## **M & M COMMERCIAL PARK SUBDIVISION,** **SECOND ADDITION**

APPLICATION NUMBER 4 DATE January 18, 2007  
APPLICANT M & M Commercial Park Subdivision, Second Addition  
REQUEST Subdivision

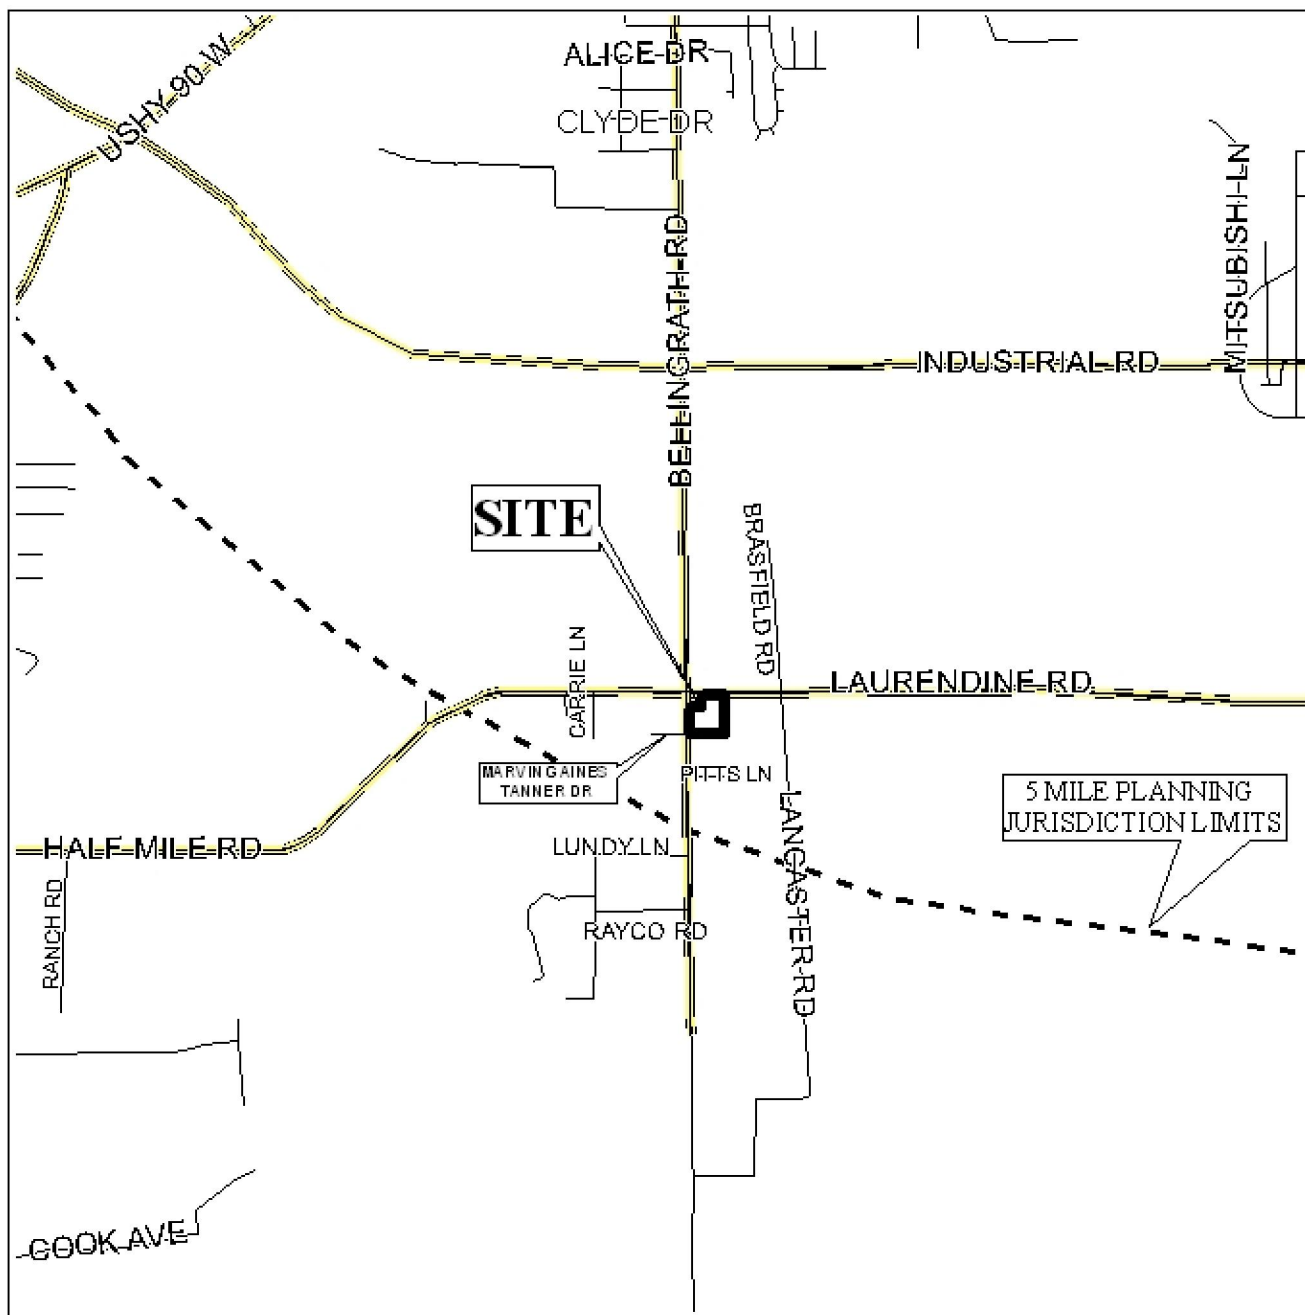
The purpose of this application is to resubdivide one parcel into three lots. It appears that the parcel has had parts sold off without benefit of the subdivision process; it is unclear through a search of Mobile County Probate Court records if the parcel under consideration was created prior to July 1984, when Mobile County adopted the City's subdivision process. Documentation should be provided to verify when the parcel was created, and if after 1984, the plat should be revised to include all portions of the parent parcel that have been divided since that time.

The site fronts onto Bellingrath Road and Laurendine Road, both proposed major streets with rights-of-way of 80 feet. As proposed major streets, each road should have a minimum right-of-way width of 100 feet, thus sufficient right-of-way should be dedicated to Mobile County to provide 50 feet, as measured from the centerline of each road. The 25-foot minimum building setback line should be adjusted to reflect the right-of-way dedication.

As both Bellingrath Road and Laurendine Road are proposed major streets, access management is a concern. It is recommended that Lot 4 be limited to two curb-cuts onto Bellingrath Road, that Lot 5 be limited to one curb-cut onto Bellingrath Road (due to its limited frontage), and that Lot 6 be limited to two curb-cuts onto Laurendine Road, with the size, design and location of all curb-cuts to be approved by the Mobile County Engineering Department.

While the site is located in the county, compliance with the City of Mobile stormwater and flood control ordinances will be required. A letter from a licensed engineer certifying compliance with the City's stormwater and flood control ordinances should be submitted to the Mobile County Engineering Department and the Planning Section of Urban Development prior to the issuance of permits.

This site is located in Mobile County, thus a note should be placed on the Final Plat stating that any lots which are developed commercially and adjoin residentially developed property must provide a buffer, in compliance with Section V.A.7. of the Subdivision Regulations.

Based upon the preceding, the plat is recommended for Holdover until the February 15<sup>th</sup> meeting, with revisions due by January 23<sup>rd</sup>, to allow for the following: 1) provision of documentation showing the creation of the parcel prior to 1984, or revision of the plat to include the parent parcel and all divisions of said parcel since 1984, with accompanying labels and postage for additional notification.

The site was located outside of the City's planning jurisdiction when adjacent parcels and lots were sold off, thus inclusion of the "parent" parcel and subsequent subdivisions is NOT required. The site became part of the PJ after the 1998 annexation.

Based upon the preceding, the plat is recommended for TENTATIVE APPROVAL, subject to the following conditions:

- 1) dedication of sufficient right-of-way to Mobile County to provide 50 feet, as measured from the centerline of Bellingrath Road and Laurendine Road;

- 2) adjustment of the 25-foot minimum building setback line to reflect the right-of-way dedication;
- 3) placement of a note on the final plat stating that Lot 4 is limited to two curb-cuts onto Bellingrath Road, that Lot 5 is limited to one curb-cut onto Bellingrath Road, and that Lot 6 is limited to two curb-cuts onto Laurendine Road, with the size, design and location of all curb-cuts to be approved by the Mobile County Engineering Department;

- 4) placement of a note on the plat stating that a letter from a licensed engineer certifying compliance with the City of Mobile's stormwater and flood control ordinances must be provided to the Mobile County Engineering Department and the Planning Section of Urban Development prior to the issuance of permits;

- 5) labeling of each lot with its size in square feet, or provision of a table on the plat with the same information; and
- 6) placement of a note on the Final Plat stating that any lots which are developed commercially and adjoin residentially developed property must provide a buffer, in compliance with Section V.A.7. of the Subdivision Regulations.
